APPLICATION NO.	FILING DATE	FIRST NAMED INVENTOR	ATTORNEY DOCKET NO.	CONFIRMATION NO.
10/809,870	03/26/2004	Yoshihito Asao	Q80584	7600
23373 7590 10/02/2007 SUGHRUE MION, PLLC			EXAMINER	
2100 PENNSYLVANIA AVENUE, N.W. SUITE 800 WASHINGTON, DC 20037			RUTLAND WALLIS, MICHAEL	
			ART UNIT	PAPER NUMBER
			2836	
			<u> </u>	
			MAIL DATE	DELIVERY MODE
			10/02/2007	PAPER

Advisory Action	
Before a	the Filing of an Appeal B	rief

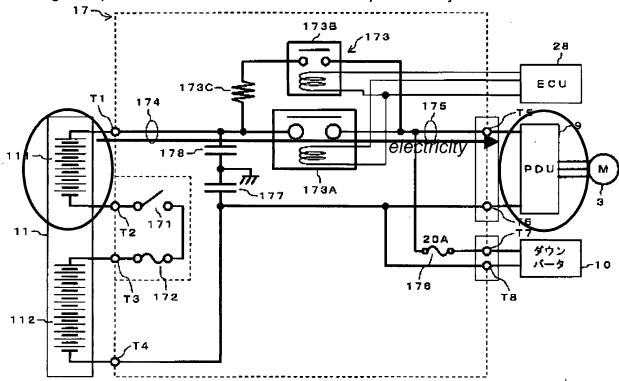
Applicant first argues there is no teaching or suggestion that the base plate 170 or the junction board 17 electrically connect a battery and an inverter unit.

In response Drawing 4 is reproduced below in effort to clarify the disclosed connection. It may be may be clearly seen below the connection which interfaces the battery and inverter (both circled below) is the junction board. Therefore the cited teachings are present and sufficient to maintain the previous rejection.
